# Glenilla Road

Non Material Amendment  
11 September 2023

This report highlights the proposed amendments to the consented application no 2016 6712 P.  
The proposed changes are due to design and programme refinement.

Roof Plan - Consented

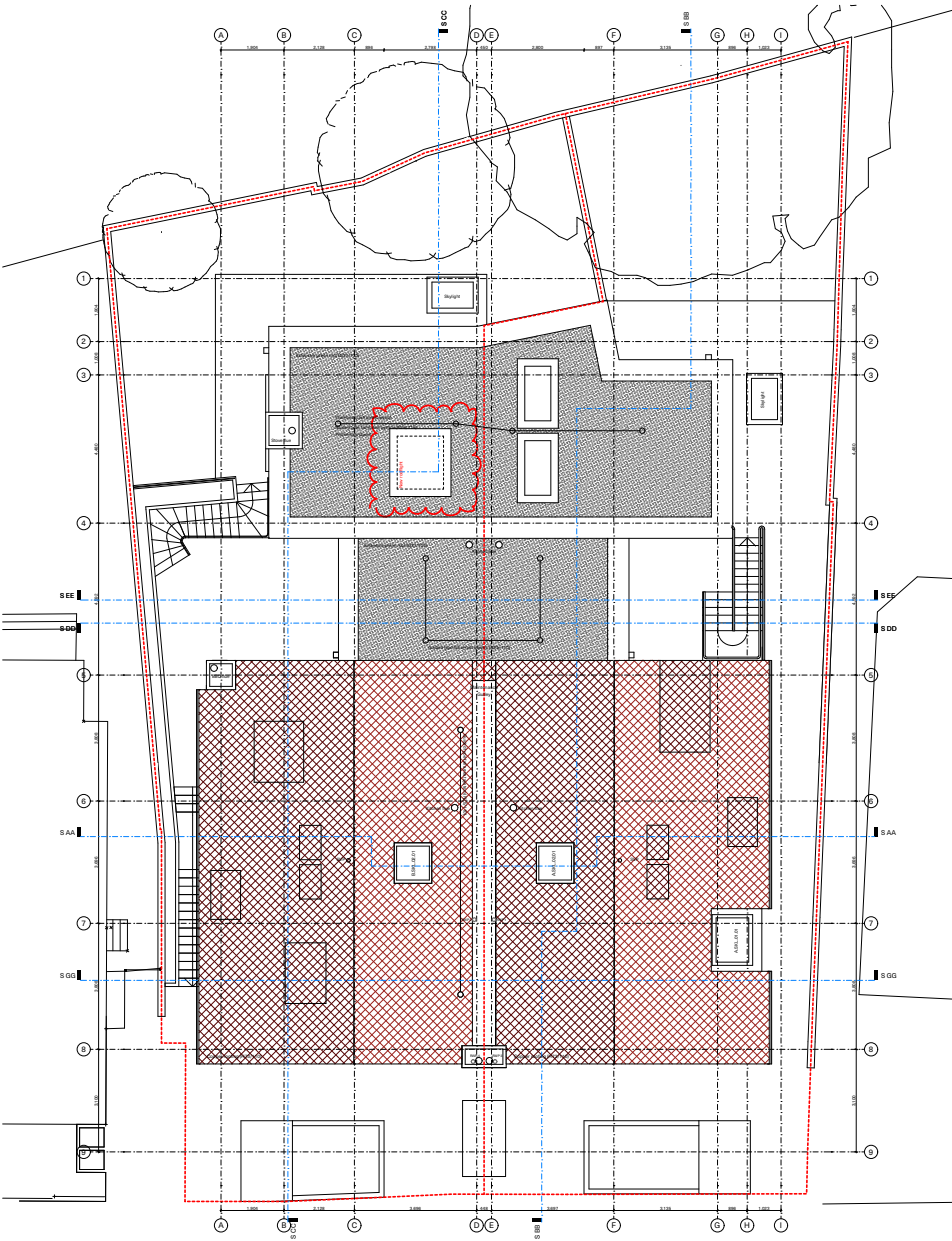
Since original planning application surrounding trees have grown considerably and are generating a substantial amount of shading at the rear of no32 site.

One new rooflight is proposed for the rear extension roof over 32b property. This will bring natural light to the darkest area of the ground floor living space.

A single larger (than 32a) rooflight will create a more agreeable roofscape as opposed to rigid repetition.
